GM BEDFORD REMOVAL ACTION SITE SOURCE CONTROL PLAN, ADDENDUM NO. 2

GM POWERTRAIN BEDFORD FACILITY BEDFORD, INDIANA

CONESTOGA-ROVERS & ASSOCIATES

**GM BEDFORD REMOVAL ACTION
SITE SOURCE CONTROL PLAN
ADDENDUM NO. 2
AREA NORTH OF AO14
COLLECTION SYSTEM C PLAN AND PROFILE**

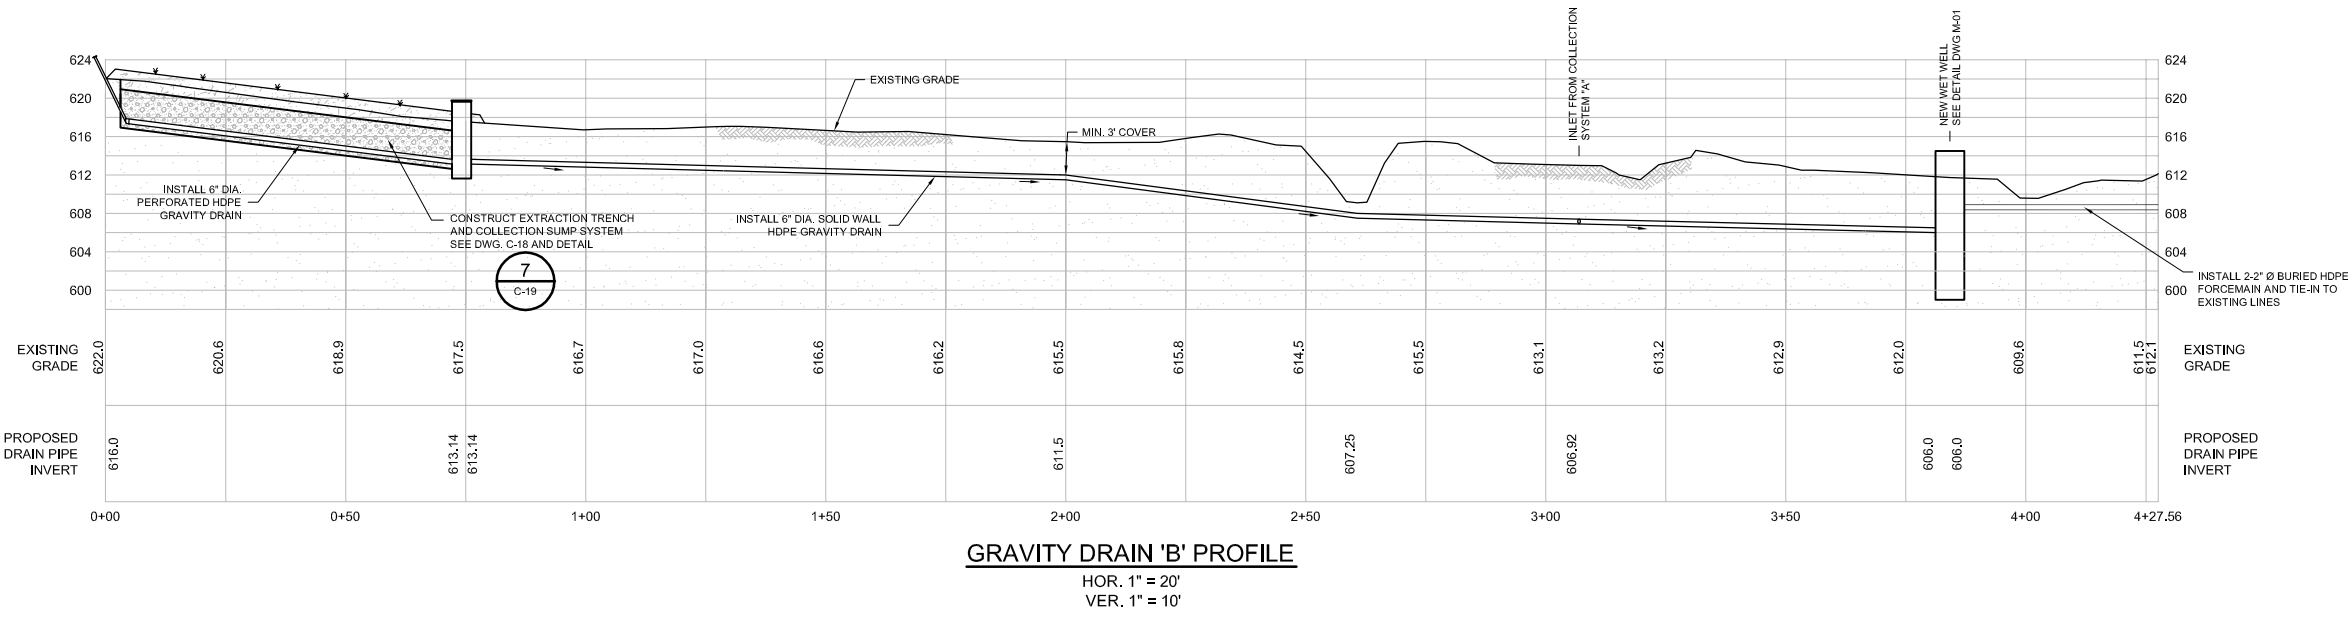
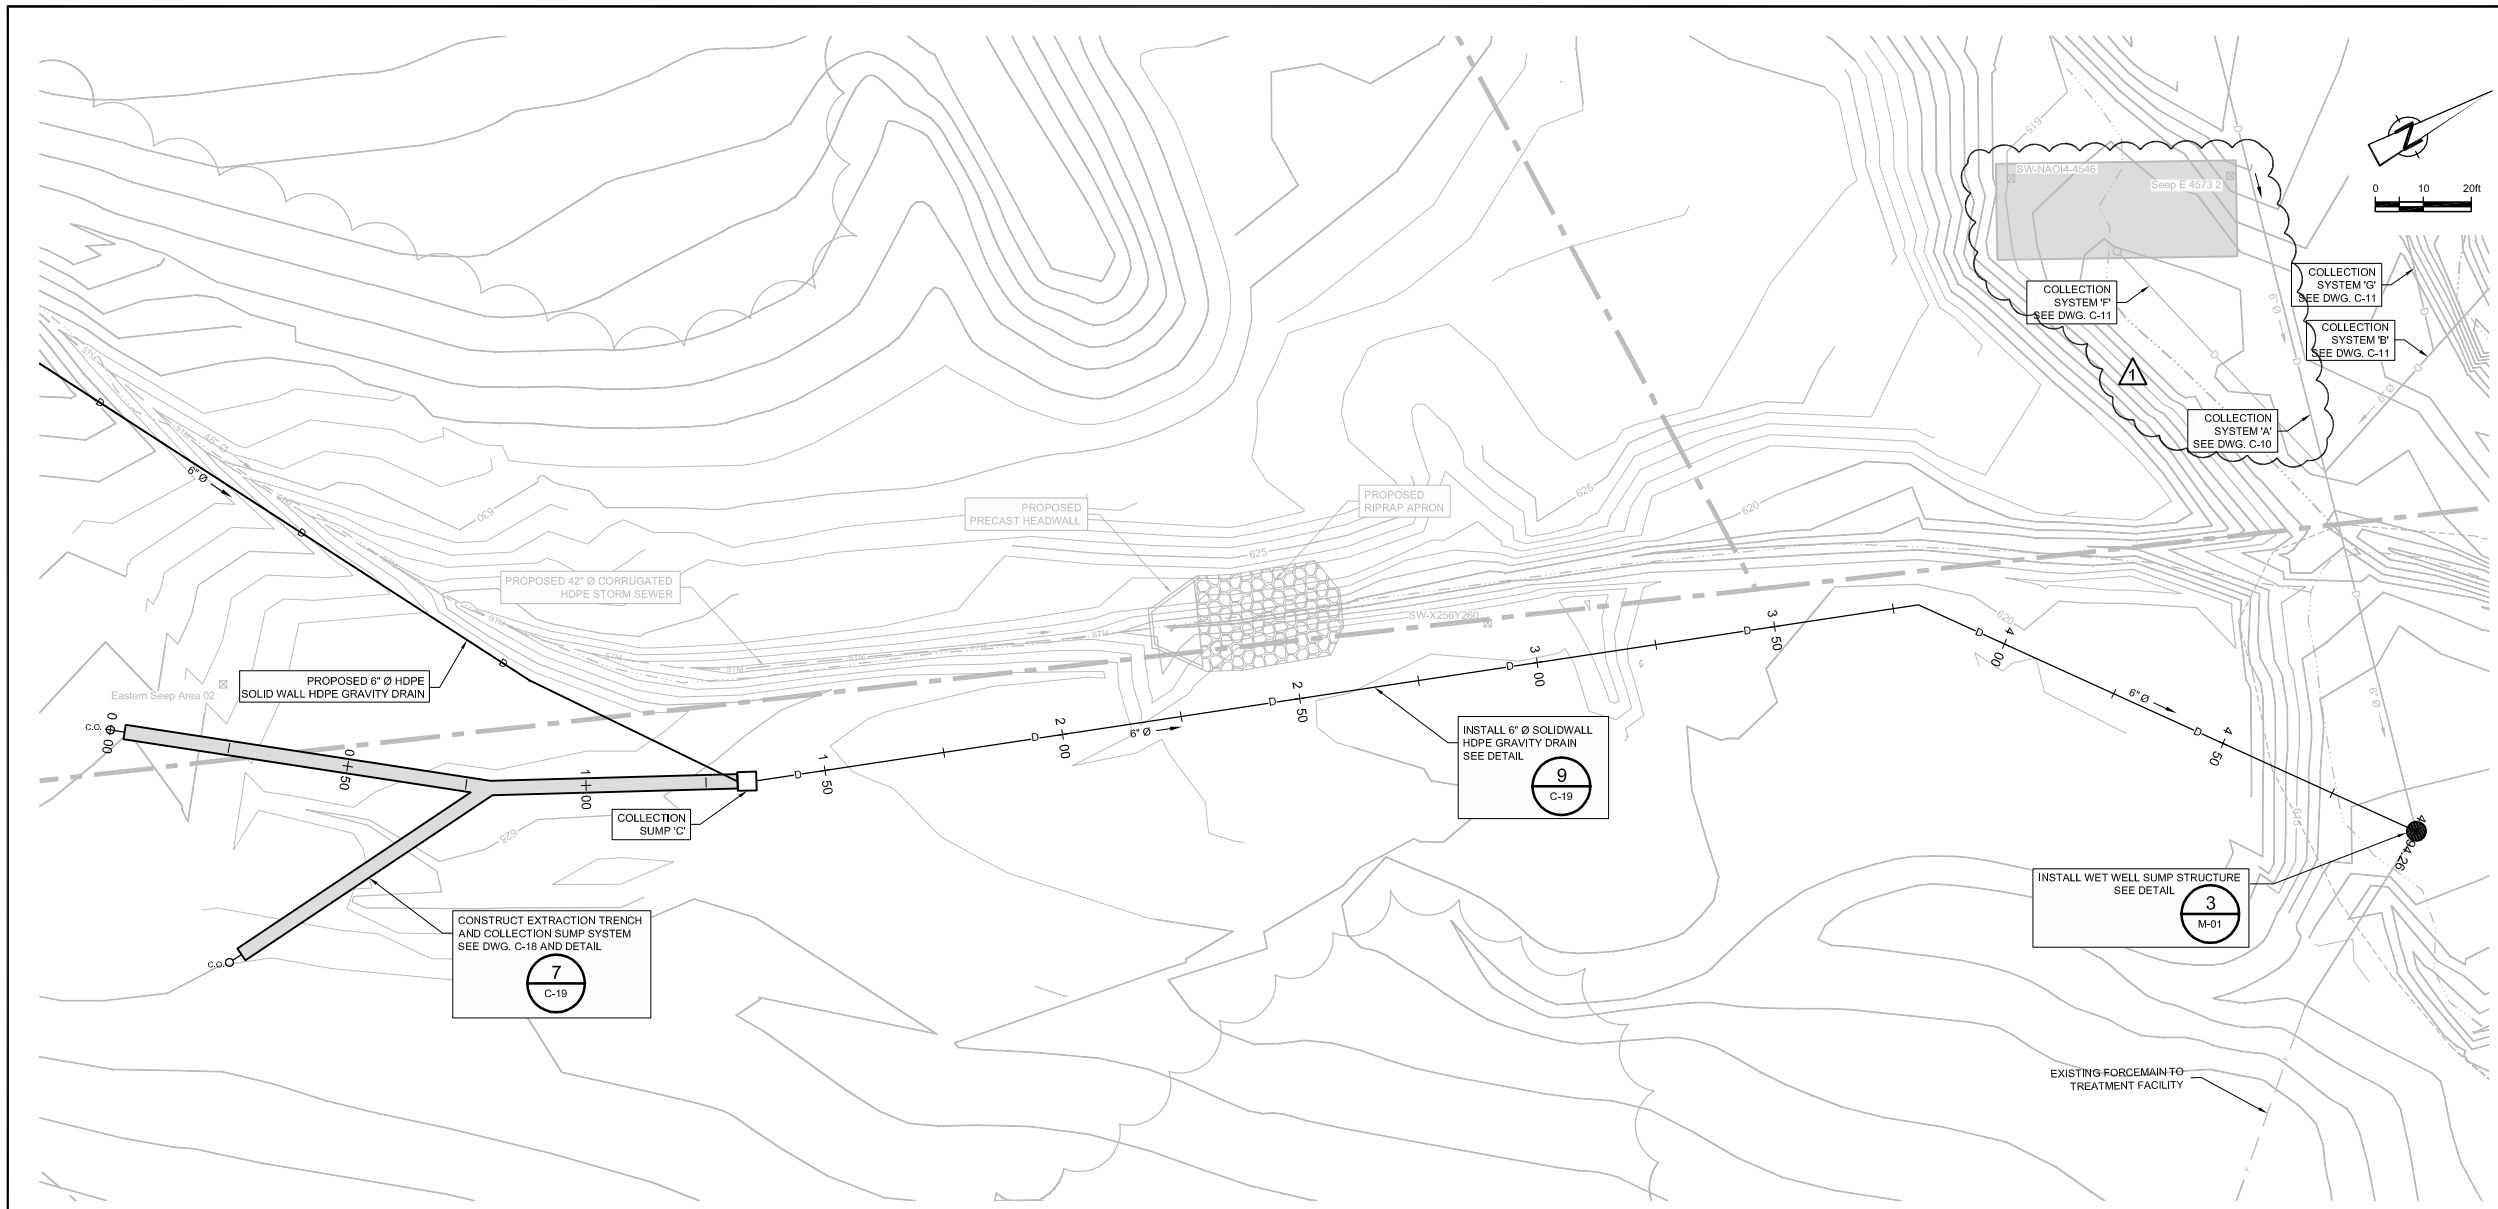
NO	Revision	Date	Initial
1	ADDITIONAL SEEP COLLECTION AREAS	OCT 18, 2004	CRH

**GM BEDFORD REMOVAL ACTION
SITE SOURCE CONTROL PLAN**
ADDENDUM NO. 2
**AREA NORTH OF AO14
STORM SEWER PLAN AND PROFILE**

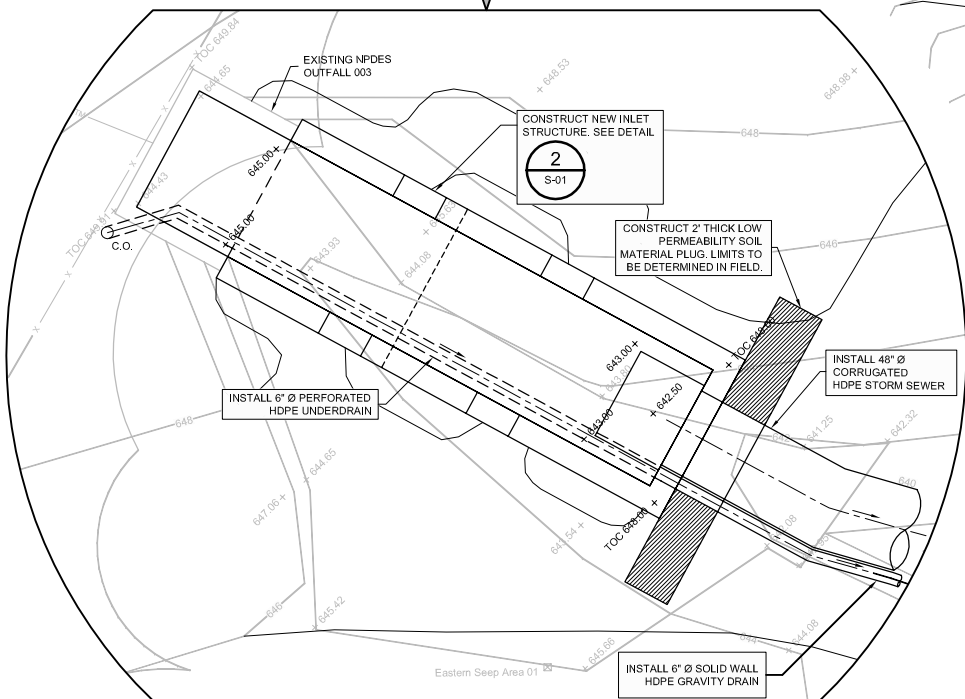
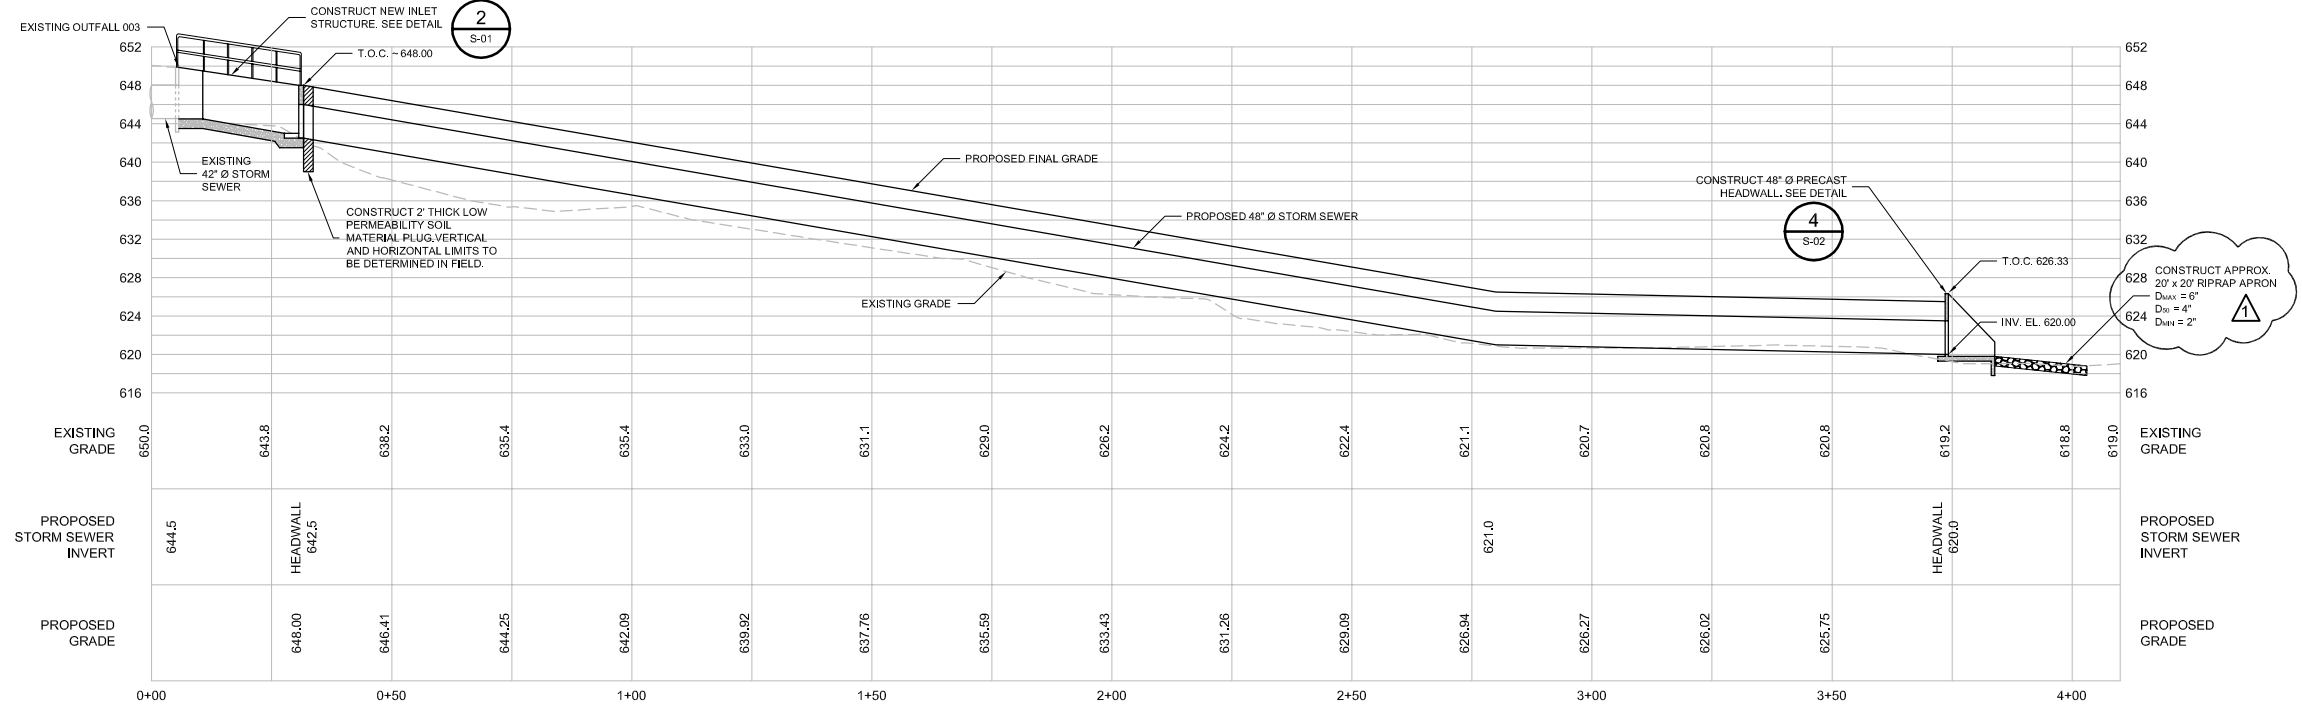
NO	Revision	Date	Initial
1	RIPRAP APRON TEXT BOX REVISED TO SHOW STONE	AUG 20, 2004	AW
	GRADATION ON SEWER PLAN AND SEWER PROFILE

**PARCEL 3 AND 205
GRADING PLAN**

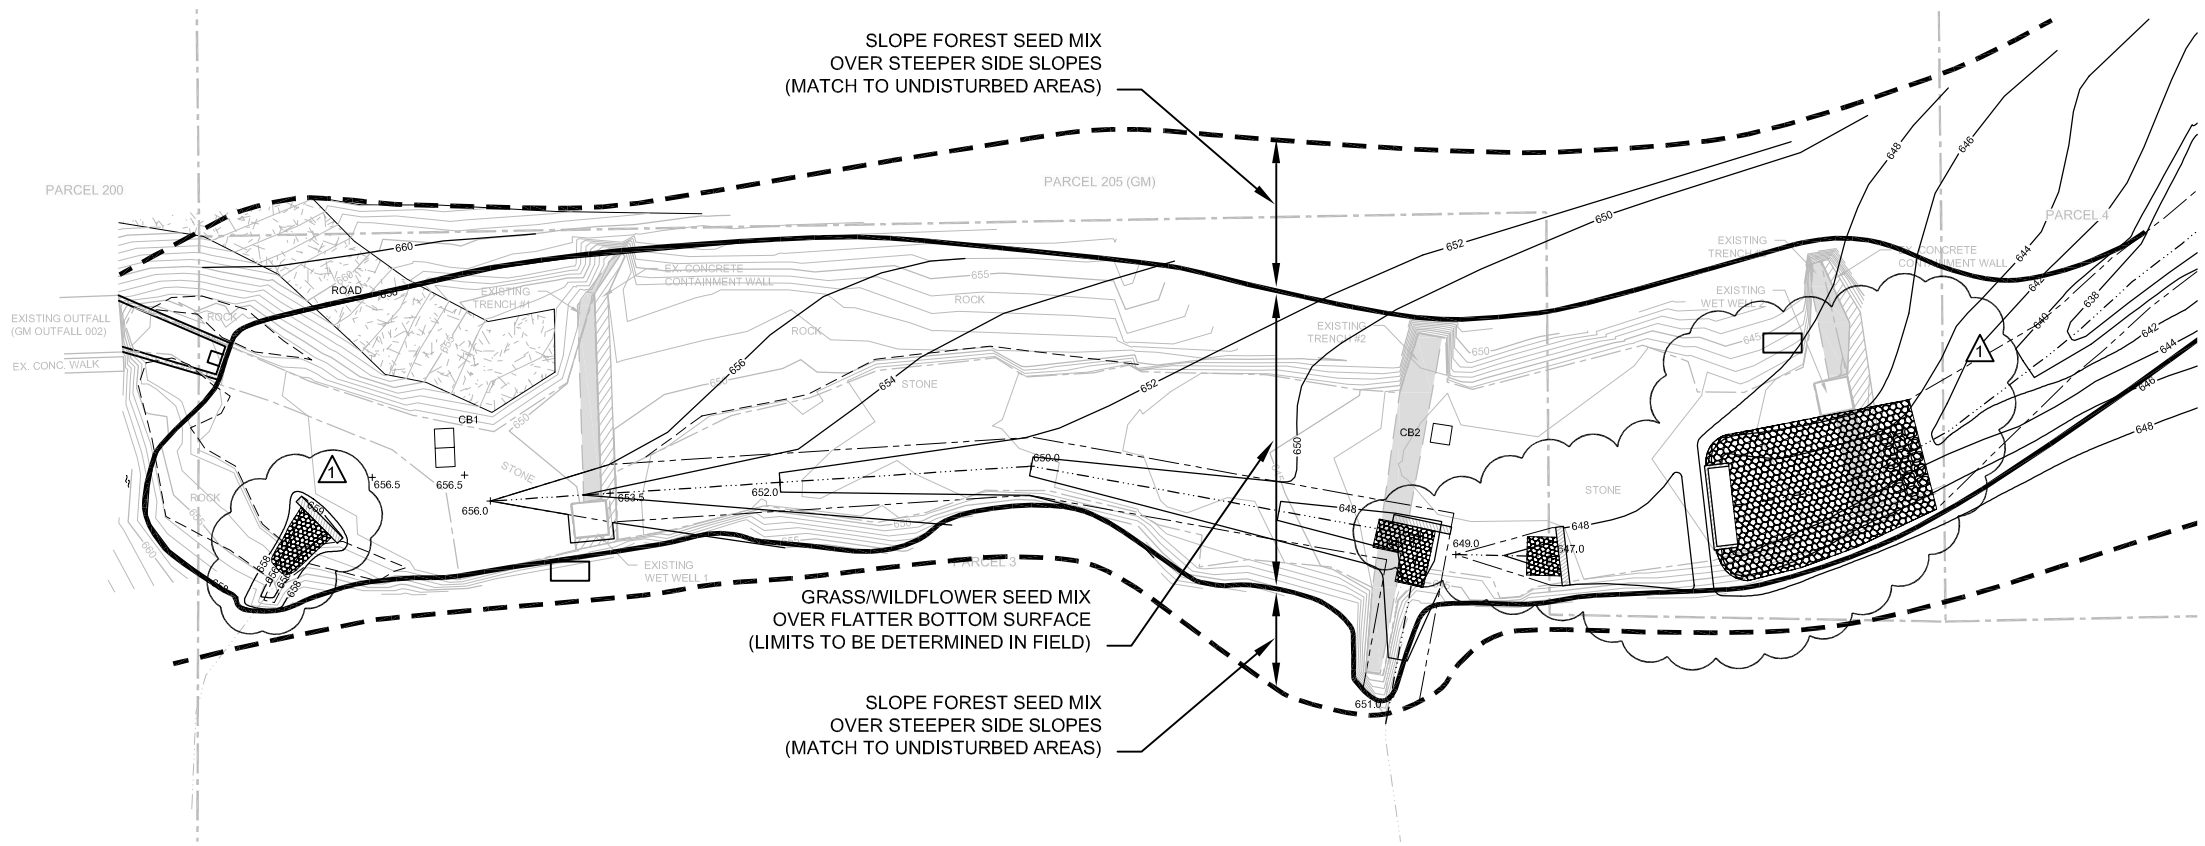
NR	Revision	Date	Initial
1	POSITION OF NEW OUTFALL STRUCTURE AND NEW DRAINAGE INLETS REVISED.	AUG 20, 2004	AW
	PROPOSED CONTOURS REVISED IN AREAS SHOWN

**GM BEDFORD REMOVAL ACTION
SITE SOURCE CONTROL PLAN**
ADDENDUM NO. 2
PARCELS 3 AND 205
STORM SEWER DETAILS I

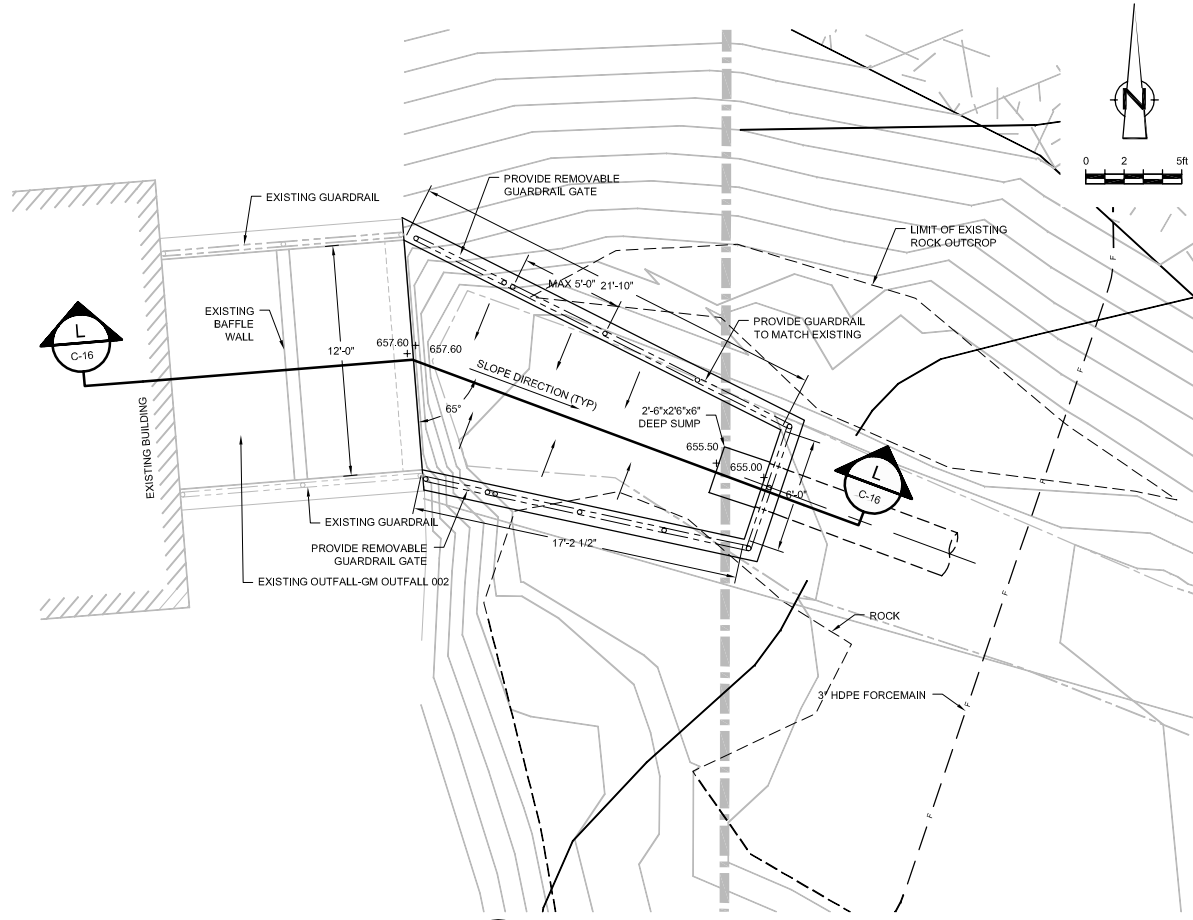
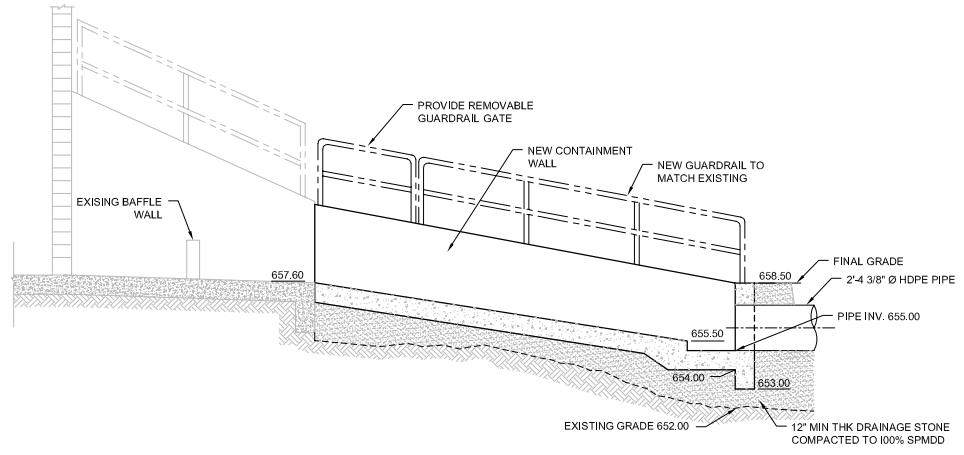
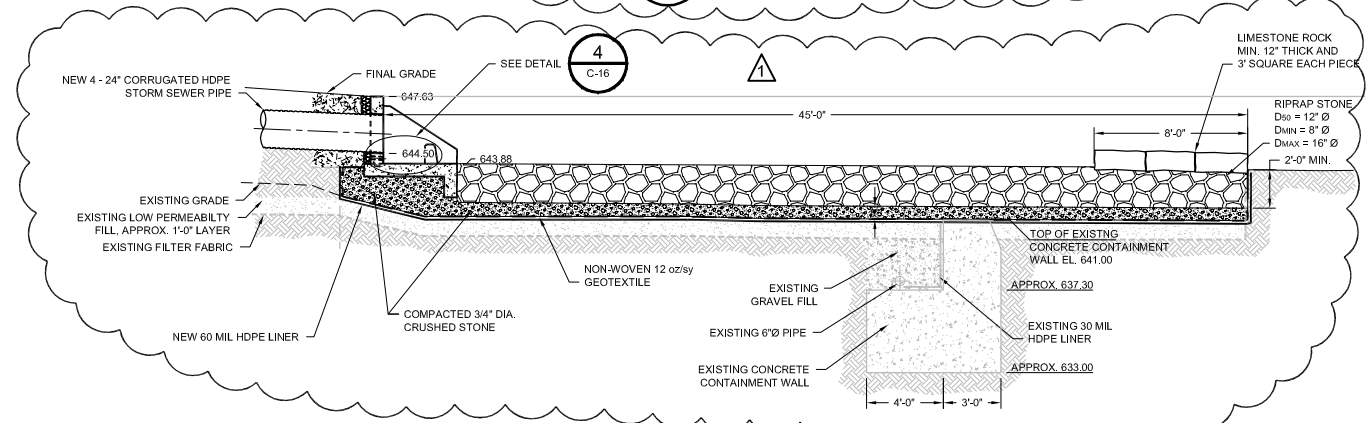
NO	Revision	Date	Initial
1	DETAIL 3 - POSITION OF NEW OUTFALL STRUCTURE REVISED, PROPOSED CONTOURS REVISED, AND PROPOSED INVERT ELEVATION REVISED	AUG 20, 2004	AW
	SECTION M - POSITION OF NEW OUTFALL STRUCTURE REVISED, INVERT ELEVATION REVISED, RIPRAP STONE GRADATION ADDED AND LIMESTONE ROCK POSITION REVISED		
	DETAIL 4, INVERT ELEVATIONS REVISED
